DEVELOPEMENT RIDGE TILES WACOL 070223

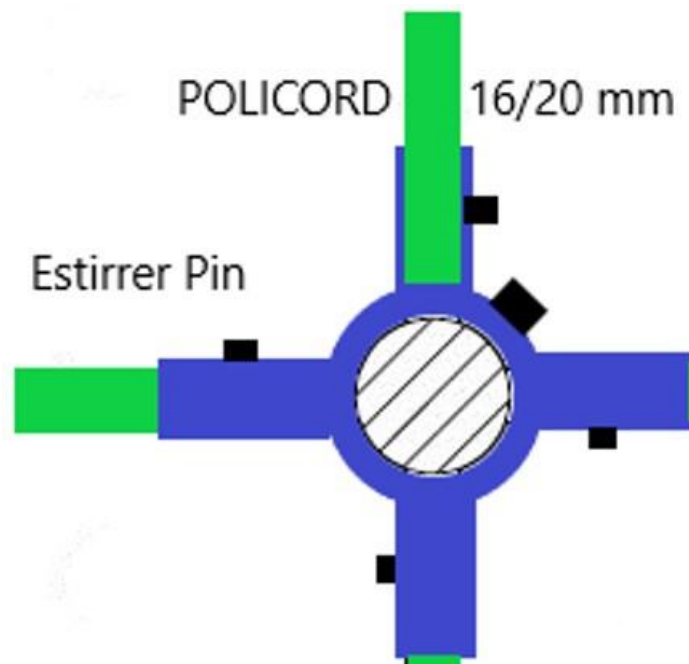
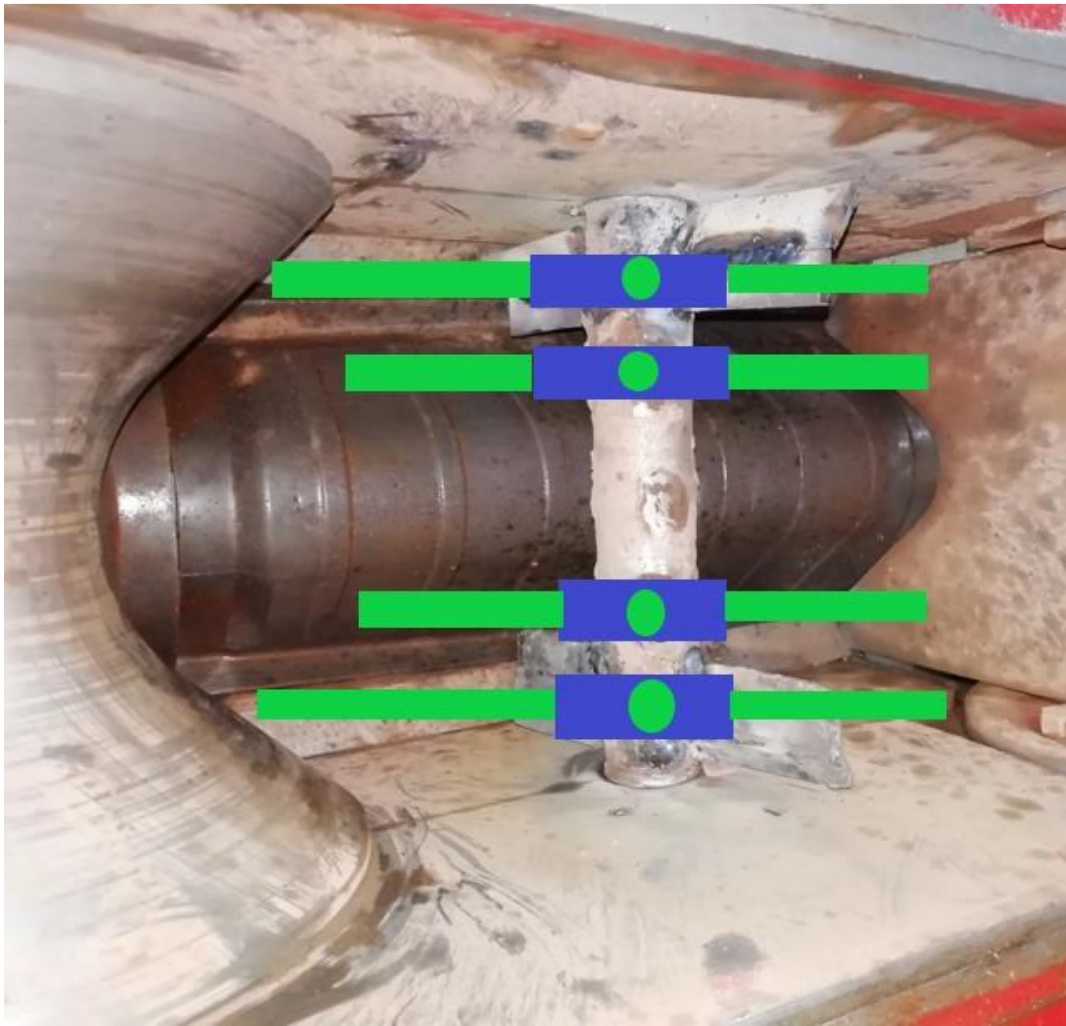
Test with the same pin stirrer, but think about a possible change in the distribution of the type of stirrer pin.

Depending on the concrete feed obtained on the pallet.
